DfT Reference: TWA/24/APP/03
Document Ref: CD26-01-APP-W9-3
The Cambourne to Cambridge Order

APPENDICES TO PROOF OF EVIDENCE
of
Jack Southon
of WSP

CAMBOURNE TO CAMBRIDGE (BIN BROOK HYDRAULIC MODEL REVIEW)

Figure 16- Glass walling in 2d

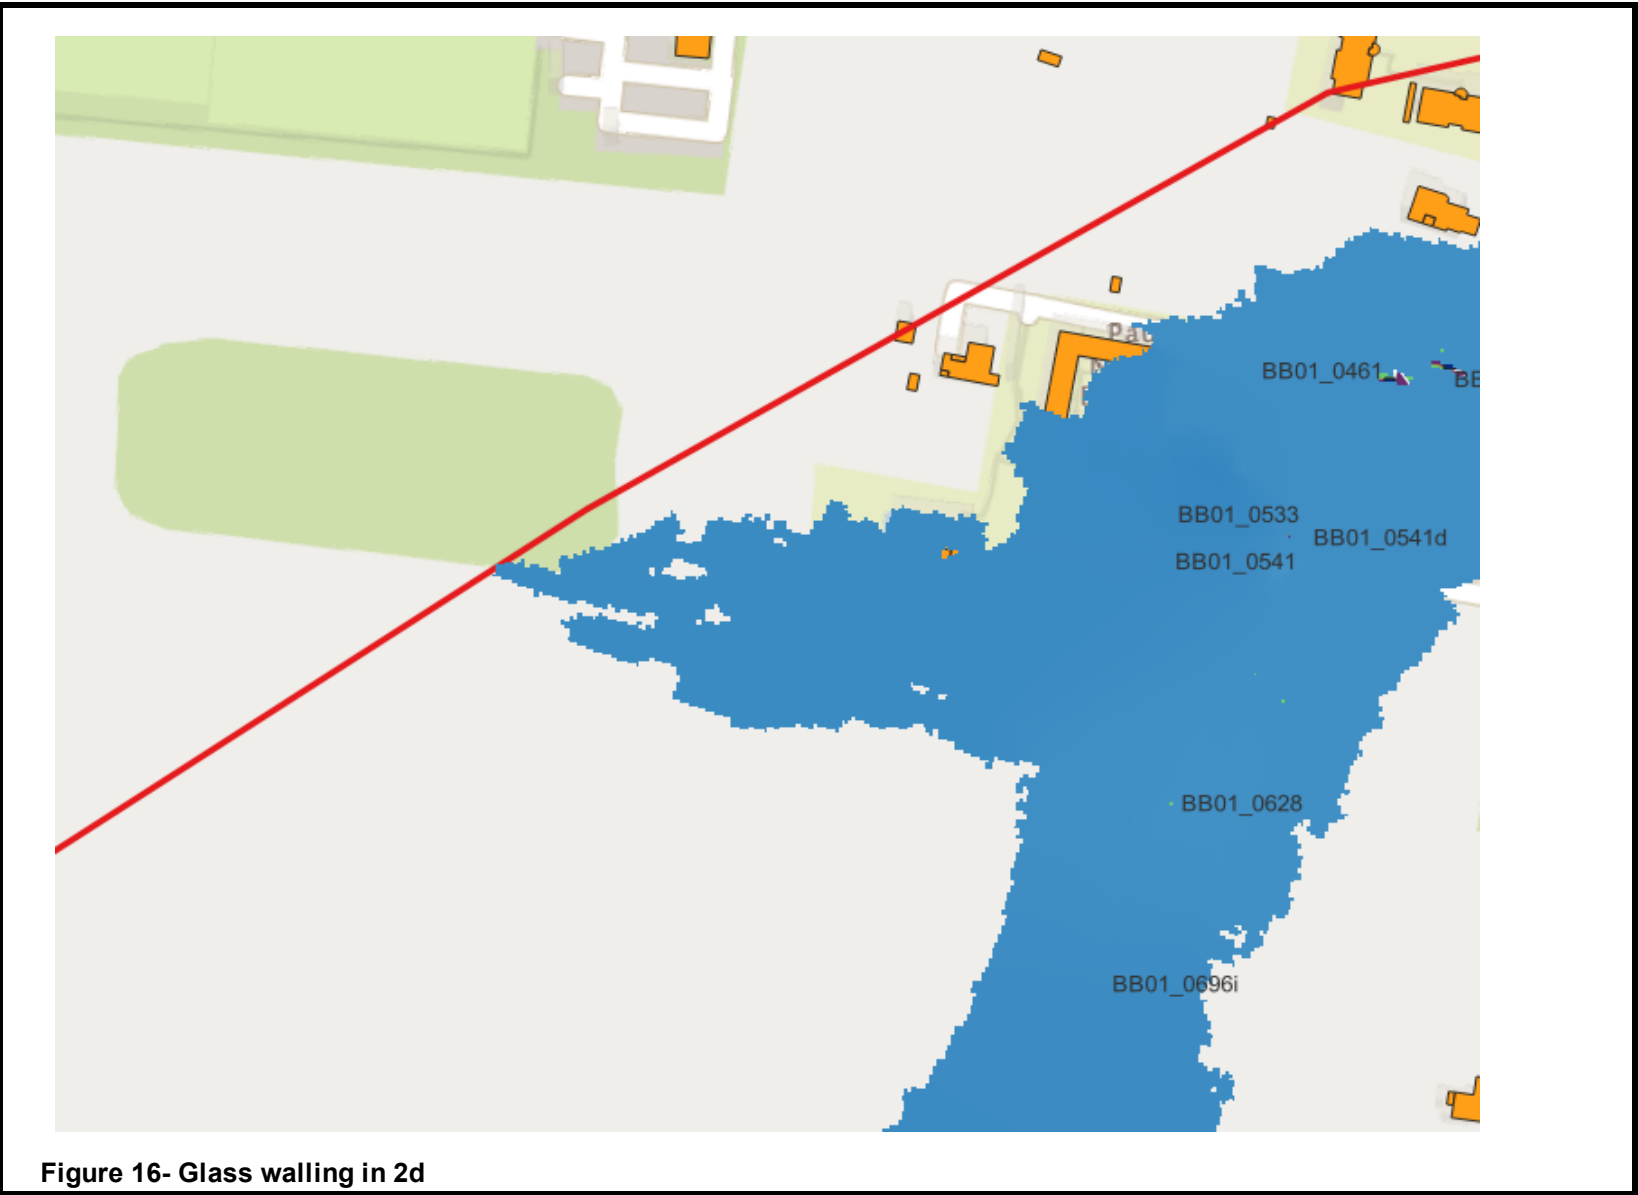
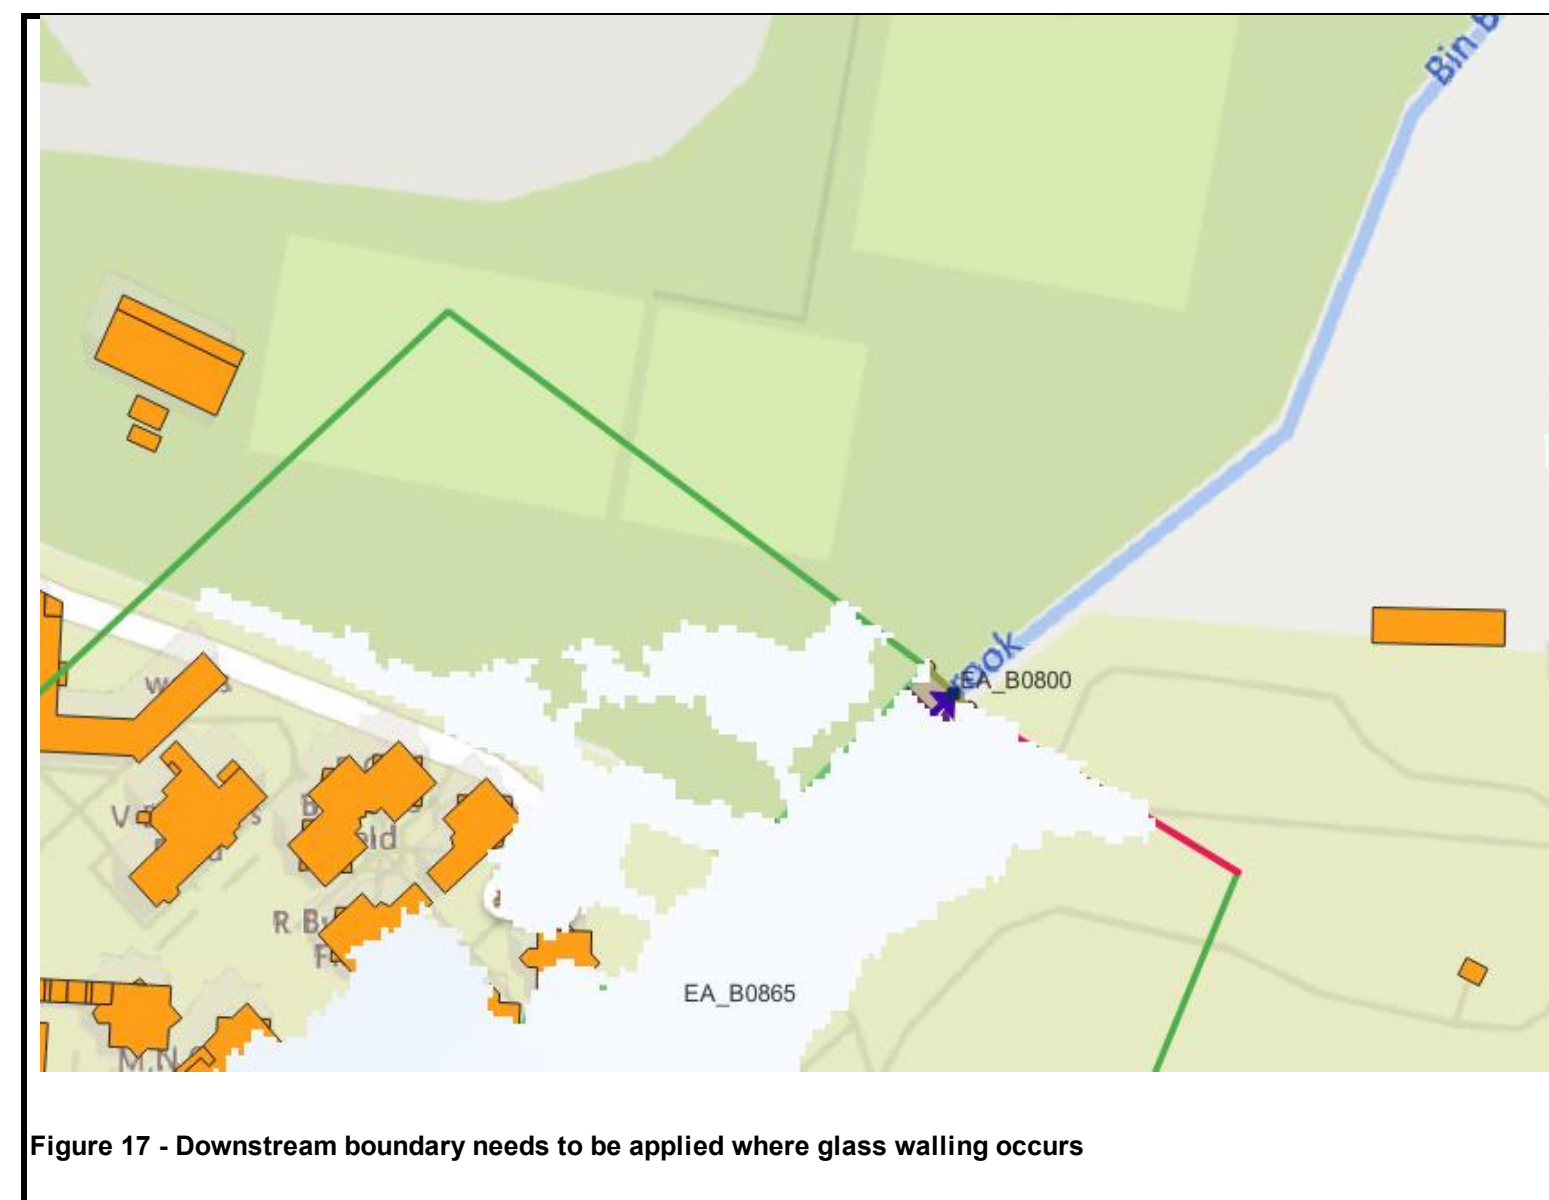
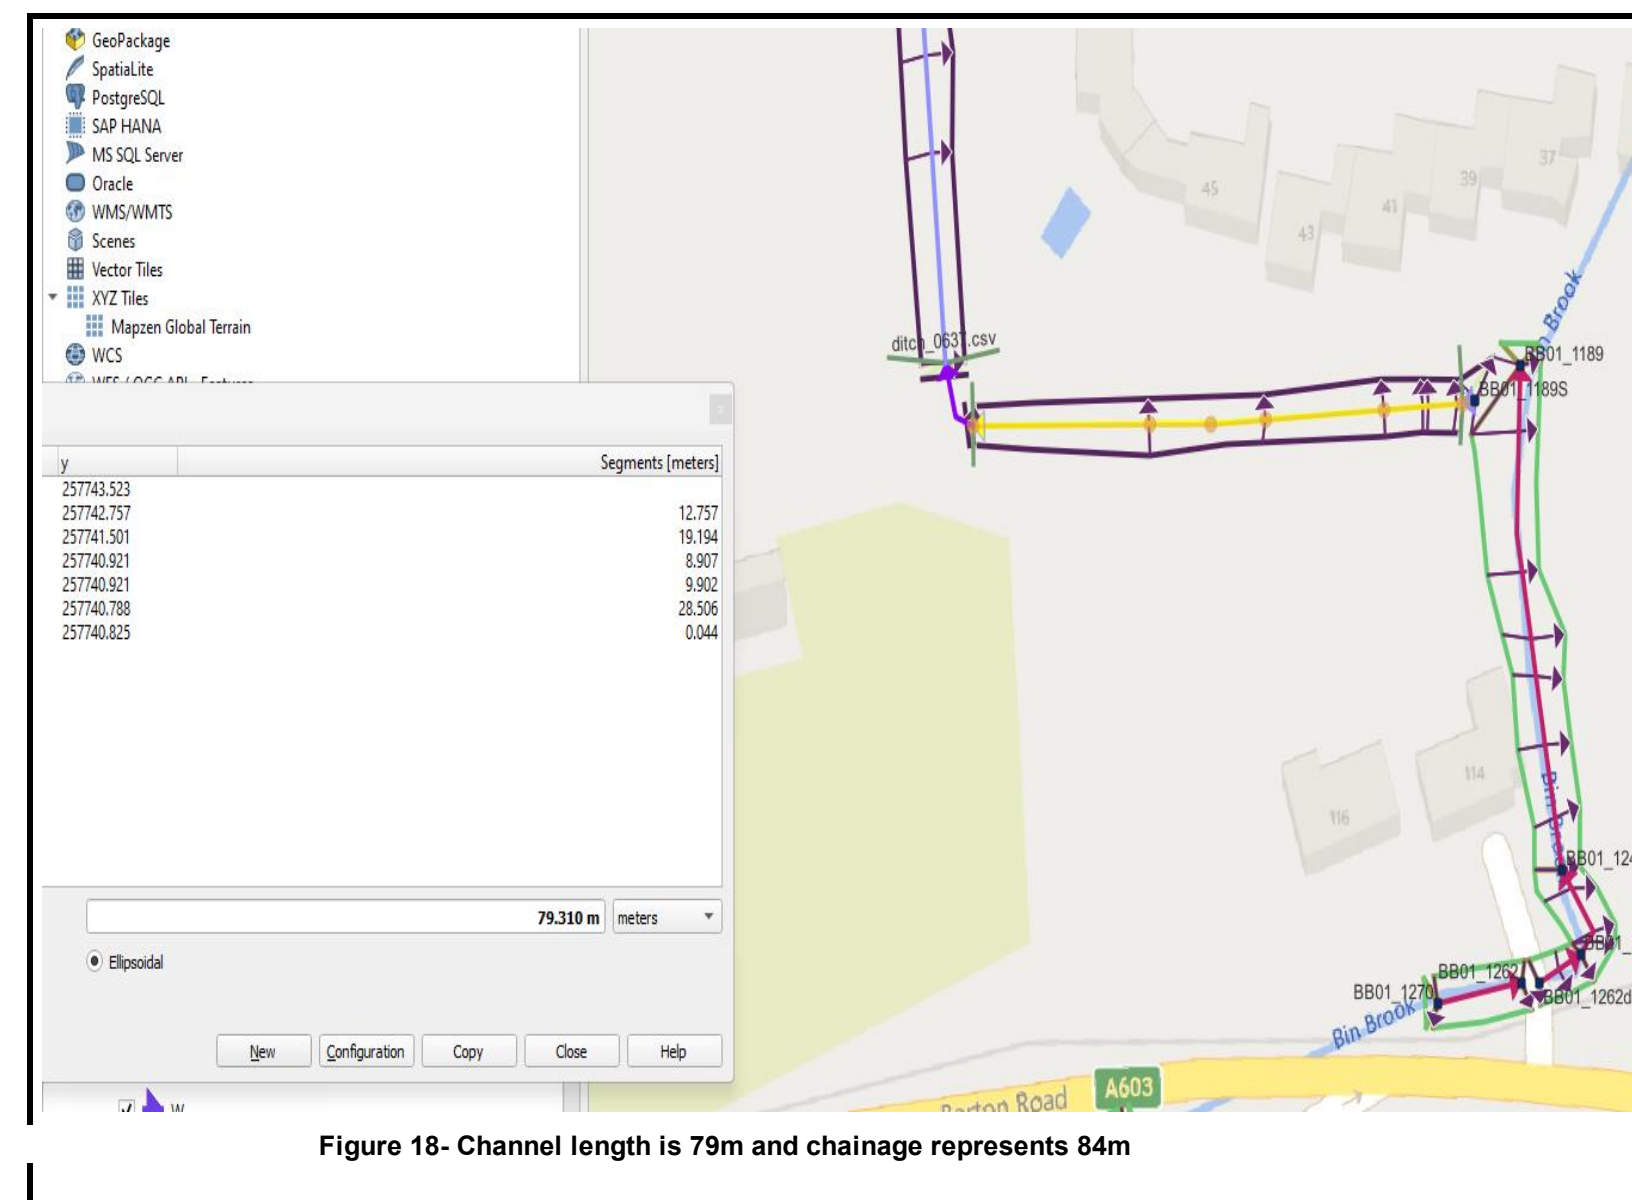
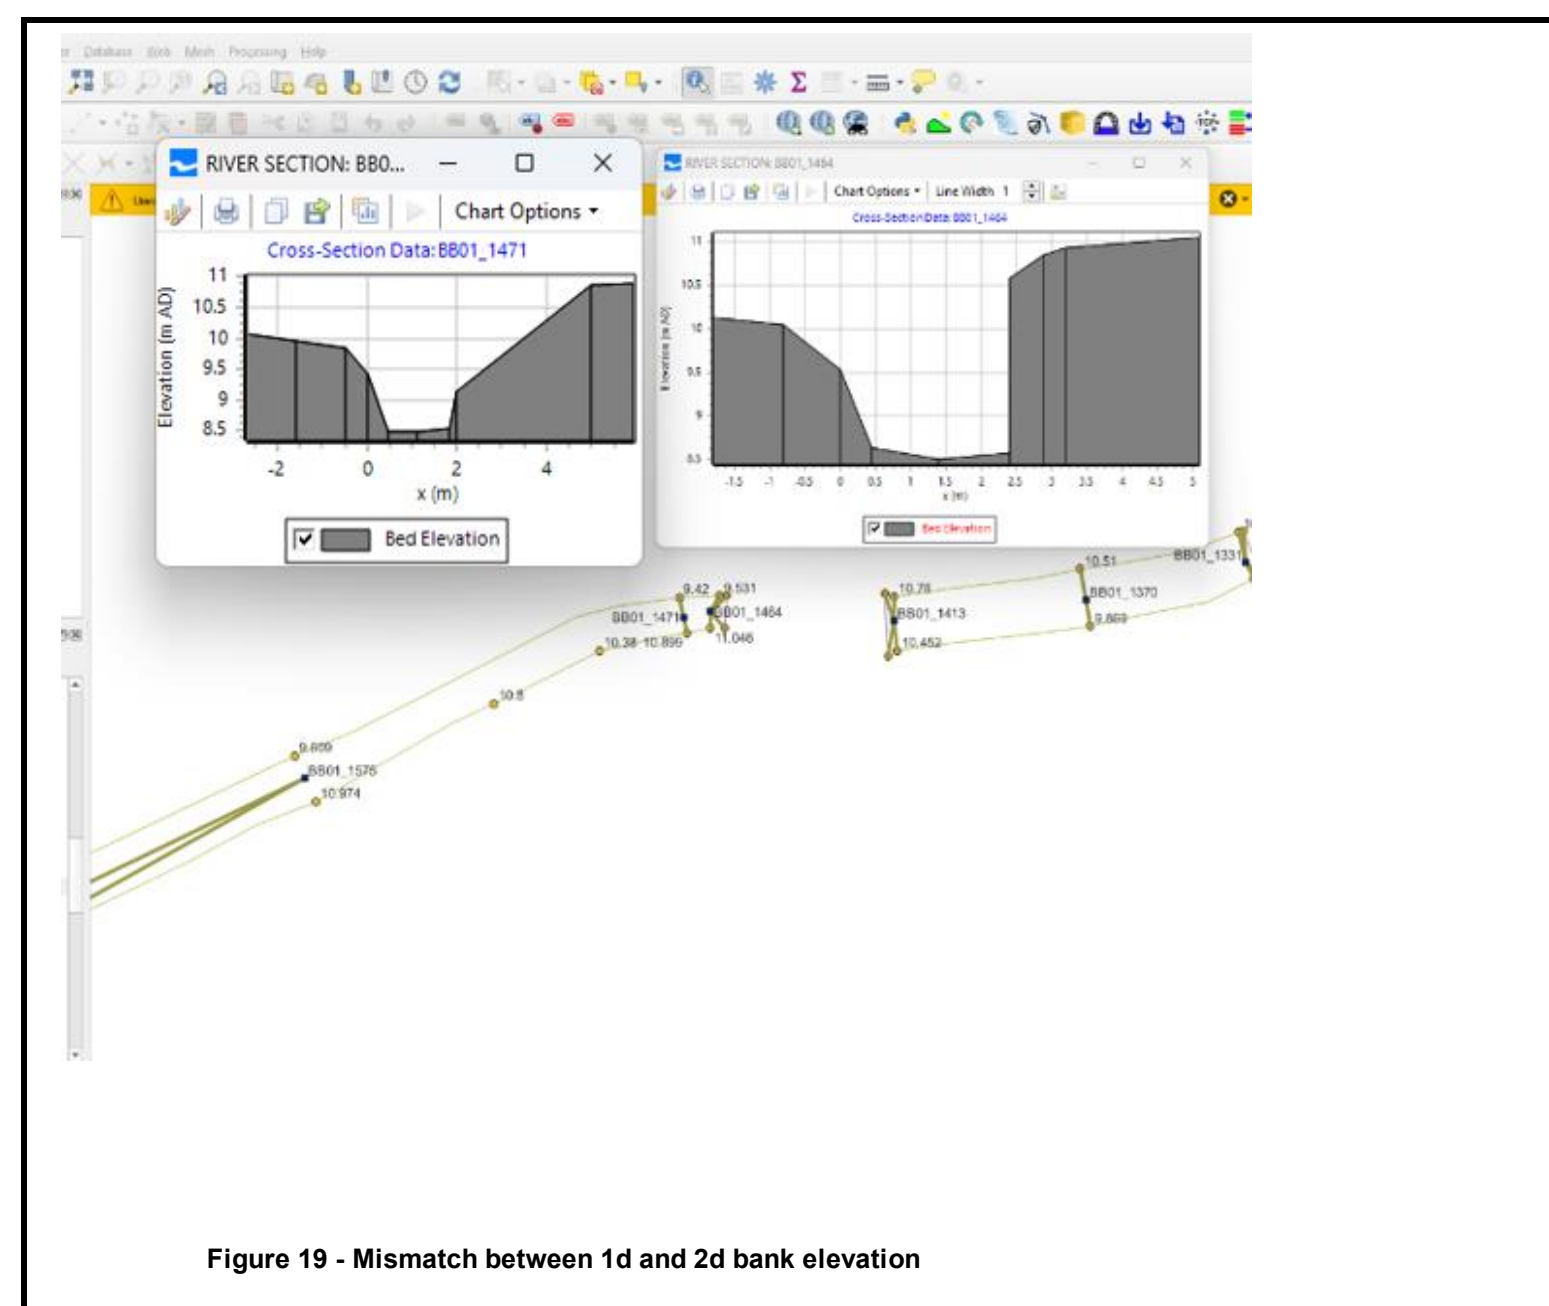
7.1	Number of domains?	OK	One 2D domain.						
7.2	Area of 2d domain/s	Red	55 hectares. There is glass walling occurring in the 1,000-year +19% CC results near Clare Hall Gym and Pool in both the Baseline and Proposed modelling.	The code layer needs to be extended to prevent glass walling.	Code layer extended upstream.	Red	There is still some glass walling - please see Figure 16.
